Permit Type	Permit Number	Opened Date
Building/Residential/Alteration/SFD	825000946	03/14/2025

**Description of Work**  
 SFD/ Finish 44x37 area IN BASEMENT To include bedroom 19x14 w/full bath (ex. egress window)\*\*SLEEPING ROOMS MUST MEET EGRESS REQUIREMENTS, SMOKE DETECTORS REQUIRED, SUBJECT TO FIELD INSPECTION\*\*

BARRY RESIDENCE

**From:** Eshenbaugh, Melanie  
**Sent:** Tuesday, April 15, 2025 5:01 PM  
**To:** terripermits@yahoo.com  
**Subject:** RE: B25000946  
**Attachments:** Bedroom defintion\_HC.pdf

BASEMENT PLAN  
 SHEET #112

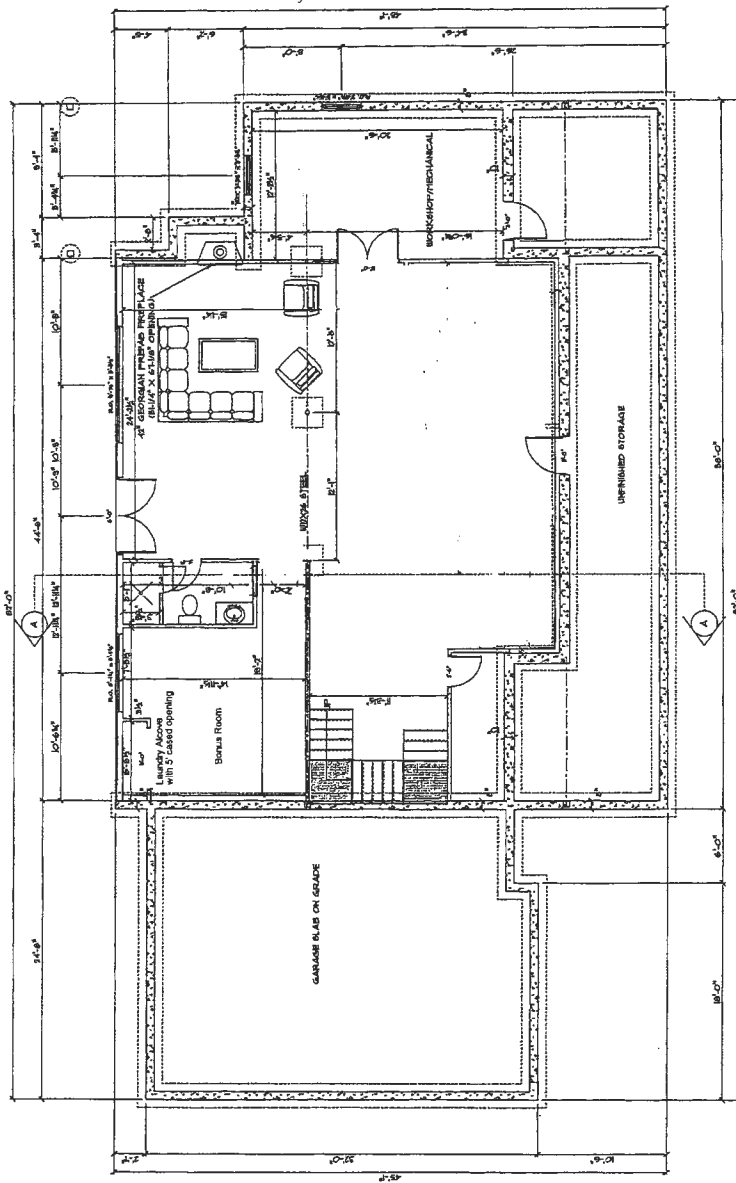
As previously stated and having discussed the floor plans with my supervisor, the bedroom count is **6** for the property to include the proposed bedroom. To gain approval of the building permit, either the office can be modified so that the room doesn't meet the HC bedroom definition, or the property owner will need to upgrade the septic system. The upgrade would require a revised onsite sewage disposal system (OSDS) plan, along with an additional 87' trench (septic permit required) to the existing system. If the property owner wishes to modify the study room, they could make a 4' cased opening or permanent bookcases/features around the perimeter of the room. I hope this explanation is clear and let me know if you have any questions. Thank you.

I have reviewed the submitted floor plan, and HCHD records and to move forward with building permit approval, we will need an updated Onsite Sewage Disposal System (OSDS) plan showing the new additional trench location for all three systems based on a 6-bedroom design flow (revisions to previously approved existing & future septic systems shown on OSDS plan). Otherwise, if there is less than 5 existing bedrooms, we would need to verify the bedroom count based on existing floor plans on the 1<sup>st</sup> & 2<sup>nd</sup> levels (see attached HD bedroom definition). Since this property has a septic system design plan and septic permit that was approved for five bedrooms, an additional bedroom would trigger an upgrade to the existing septic system of a minimum of 18ft. of trench length to accommodate finishing the basement with a bathroom/bedroom proposal. Please seek the professional services of an MDE certified engineer (see attached list, can be found on MDE website) and once the OSDS plan is approved, the septic system can then be upgraded by a licensed septic contractor on the provided list. Once all HD septic requirements have been met we can proceed with the building permit approval process. Please let me know if you have any questions and hope you have a nice weekend.

1ST FLOOR PLAN  
 SCALE: 1/8" = 1'-0"

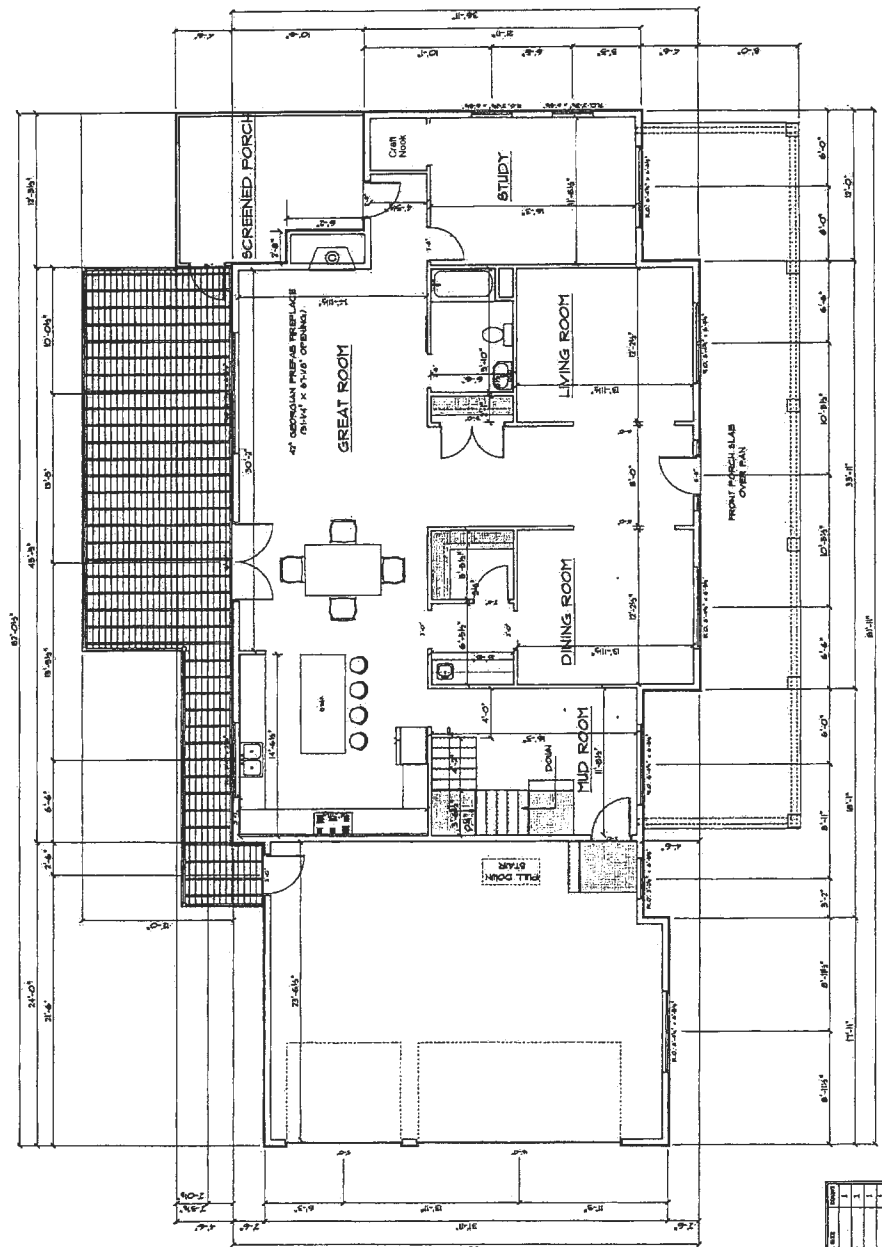
Please see the attached as previously referenced and provided. I have the direct link below of the bedroom definition in HC code. I hope this provides the clarification regarding the bedroom definition, particularly concerning the room labeled as "Study" on the 1<sup>st</sup> floor.

The floor plans have been reviewed and will need to be discussed internally regarding the HD requirements to proceed with the building permit approval. Septic systems are based on the avg. daily flow and the calculated design factors in the number of bedrooms into determining the adequate sizing for a property. The designated use and labeling of a room or space within a room can change through different ownership, and it appears that in looking at that room labeled as an office it would meet our bedroom definition. The addition or removal of a door to area of the “craft nook” could be considered closet space and there is access to a full bathroom outside of the study room. Since a bedroom addition is being proposed in the basement this would bring the total number of bedrooms to 6 and would require an upgrade to the

septic trench to ensure the septic system is sized appropriately. Otherwise, the office could be modified based on our bedroom definition to exclude this room from being designated as a bedroom (e.g. 4ft. wide cased opening, permanent fixtures, etc.). I will be following up soon after a discussion with my supervisor to inform you of his stance on this matter. Thank you kindly.

In order for us to verify and confirm the 4-bedroom count, we would need existing floor plans to do so. Our record file shows 5 bedrooms based on the original submitted floor plans when the house was proposed (Room labeled Study on 1<sup>st</sup> floor meets HC bedroom definition). If the property was constructed differently than what was on the proposed design, we would need to see those floor plans for the 1<sup>st</sup> & 2<sup>nd</sup> levels. We do not do home visits to confirm this information, but rather we review architectural plans or simplified floor plans. If you would please submit existing simplified floor plans or confirm that the ones attached to this email reflect the exact layout of the home than we can proceed with our review process. Let me know if you have any questions and thank you again.

Please see attached as-built floorplan. I see where the issue lies.

What appears to be a closet at the study ended up as a giftwrap and crafting nook, and not a closet.
